ADA Curb Ramp New Construction Inspection Form (Perpendicular)

NW 311th Ave

24952.54

NW Moon St

PERPENDICULAR RAMP (PR)

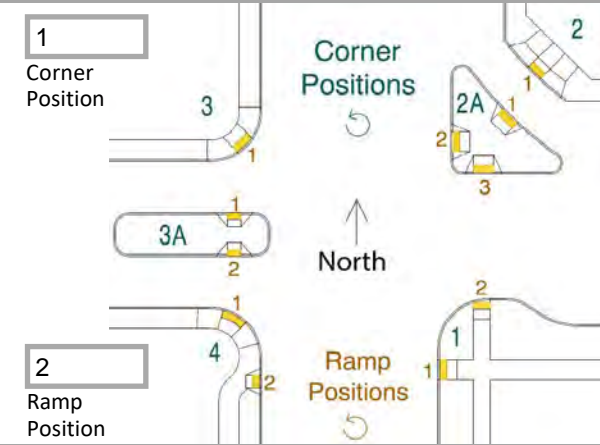
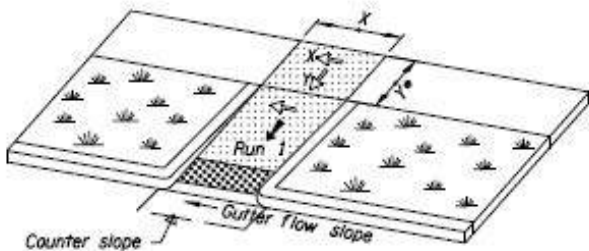
Slope X

☒

Slope Y

2.1

☒

Poor craftsmanship in gutter area
